TECHNICAL NOTE

Job Name: Station Hill North
Job No: 44470/5502
Note No: TN018
Date: 26th May 2020
Prepared By: Chris Brice
Subject: **Planning Amendment – Transport and Waste Update**

Figure 1: Plot G Cycle Store

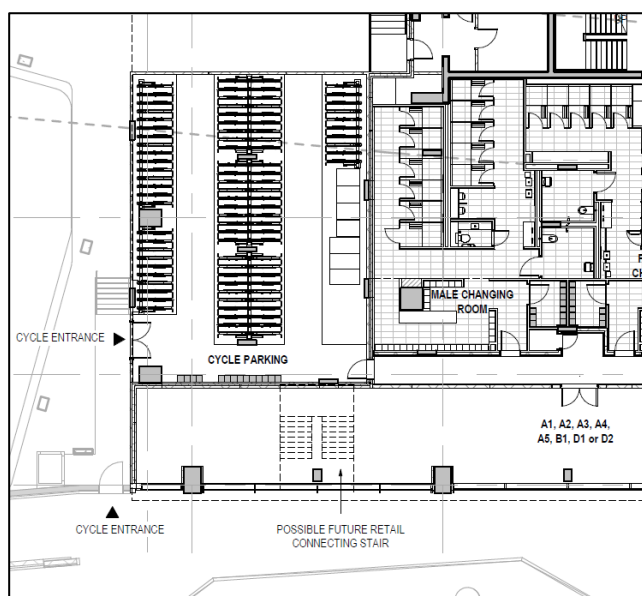
A revised cycle store is now proposed to serve Plot G, this is shown on Figure 1 below:

The cycle store accommodates 186 bicycles via two-tier cycle racks and includes lockers to store 8 Brompton style bicycles (within a two-tier locker system) with further space for 3 electric scooters/mobility scooters.

As a minimum, RBC standards specify that cycle parking for office use should be provided at 1 space per 200m².

Therefore, for the 34,736 sqm of office floor area cycle parking should be provided to store 174 bicycles for office users.

The combined staff total requirement is therefore 186 spaces, compared with the planned provision for 186 standard + 8 folding bike stores, thereby exceeding standards.

RBC's minimum cycle parking requirement is therefore exceeded by the amended scheme

Figure 2: Plot G Waste Storage Room

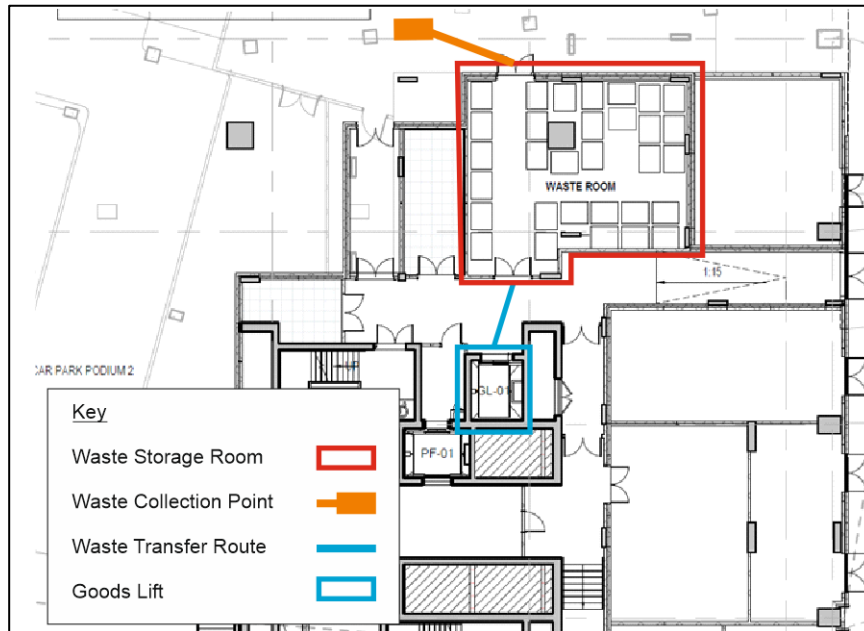
The waste storage area has therefore been designed to accommodate 31 bins which would require collections three times a week for the retail and office waste generation. The revised waste storage area is shown below in Figure 2:
